**Before the
FEDERAL COMMUNICATIONS COMMISSION
Washington, DC 20554**

)	
)	
Application of Panasonic Avionics)	File Nos. SES-LIC-20100805-00992 and
Corporation for Authority to Operate Up to)	SES-AMD-20100914-01163
15 Technically Identical Aeronautical)	
Mobile-Satellite Service (“AMSS”) Aircraft)	Call Sign E100089
Earth Stations (“AESs”) in the 14.0-14.4)	
GHz and 11.7-12.2 GHz Frequency Bands)

RESPONSE TO PETITION OF ROW 44, INC.

November 15, 2010

Figure 1. Off-axis EIRP Spectral Density for the MELCO Antenna (Horizontal-Polarization and Vertical-Polarization)

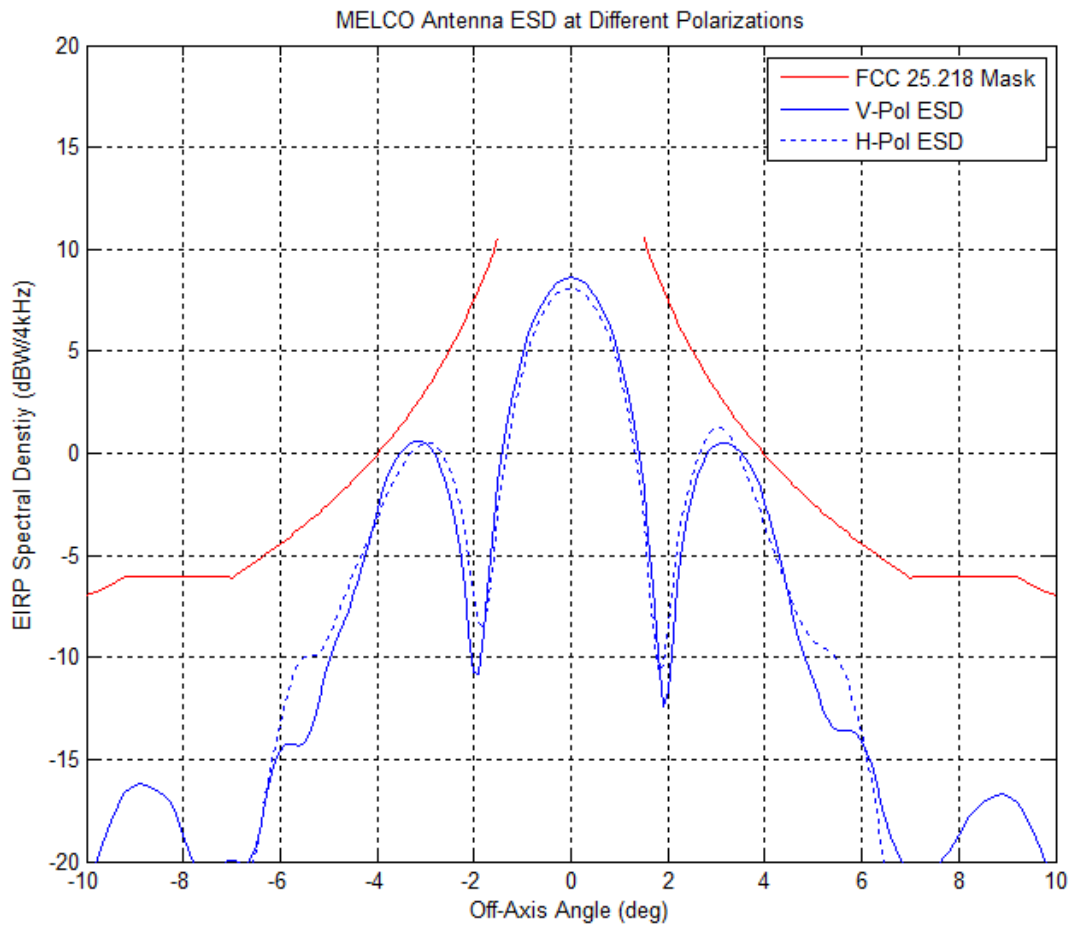
In criticizing Panasonic's antenna gain information (a criticism fully addressed by submission of complete antenna gain data with this reply), Row 44 asserts that the MELCO antenna may have significantly worse performance in the horizontal polarization given a 1 dB difference in antenna gain plots in the prior Boeing proceeding.³³ This overstates the difference in the two polarizations by failing to note that the side lobes occur at slightly different off-axis angles between polarizations and that the limiting points relative to the off-axis mask are not at the peak of the side lobe. For example, the peak of the horizontal side lobe is at approximately 3.0° off-axis in the azimuth plane while the peak of the vertical sidelobe is at approximately 3.2° off-axis. While there may be an approximately 1 dB difference in the side lobe peaks at these points, the off-axis mask at these points also differs by 0.7 dB so, relative to the mask, the net difference at the sidelobe peaks is only a few tenths of a dB.

Row 44 specifically referenced a set of azimuth plane gain plots for 14.2 GHz from the Boeing application when citing the difference in the horizontal and vertical gain patterns.³⁴ Figure 1 shows an example off-axis EIRP spectral density for both polarizations in the azimuth plane based on the azimuth plots referenced by Row 44. The vertical polarization maximum EIRP spectral density is set at 8.6 dBW/4 kHz and the maximum EIRP spectral density for the horizontal polarization has been set so as to produce no more off-axis EIRP relative to the mask than for the vertical polarization case. The difference in maximum EIRP spectral density is only 0.5 dB, which is nearly inconsequential – particularly when, as shown in Figure 1, the levels in both polarizations remain below the mask. This remains essentially constant over the operating skew angles. When operating in horizontal polarization, Panasonic will reduce its maximum EIRP spectral density when necessary to remain compliant with the mask.

Figure 2. Off-axis EIRP Spectral Density for MELCO Antenna (Top, Mid, and Bottom of Band)

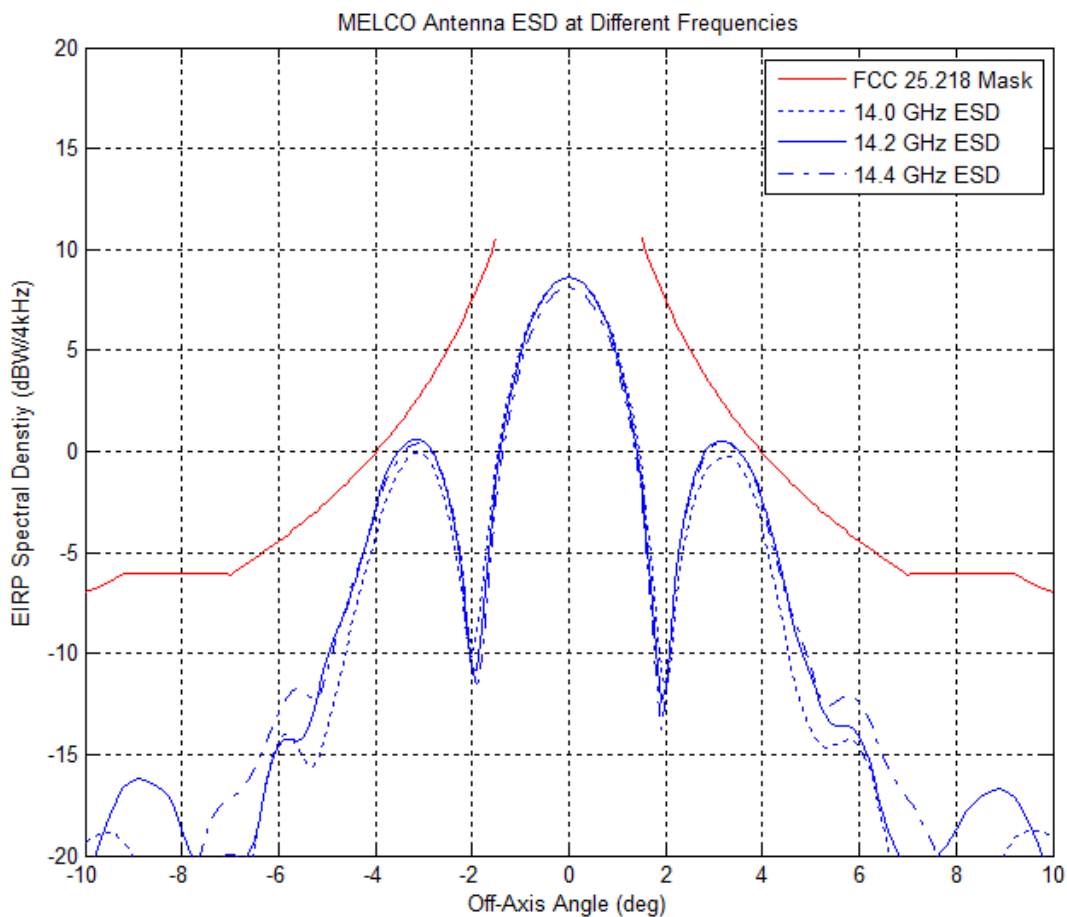
Row 44 also asserts that there will be significant variation in the MELCO antenna pattern with frequency.³⁵ This also is a gross overstatement. Figure 2 extends the example in Figure 1 across the transmit band by plotting the off-axis EIRP of the system for the top, middle and bottom of the transmit band for the vertical polarization. The middle-band maximum EIRP spectral density is set at 8.6 dBW/4 kHz and the maximum EIRP spectral density for the top and

bottom bands have been set so as to produce no more off-axis EIRP spectral density relative to the mask than the middle-band case. The difference for the bottom-band case is 0 dB – it actually produces a lower off-axis EIRP spectral density relative to the mask than the middle-band case for the same maximum EIRP spectral density. The difference for the top-band case is only 0.6 dB, which, like the polarization case, is also minor. Panasonic will reduce its peak EIRP spectral density accordingly to remain compliant when necessary.
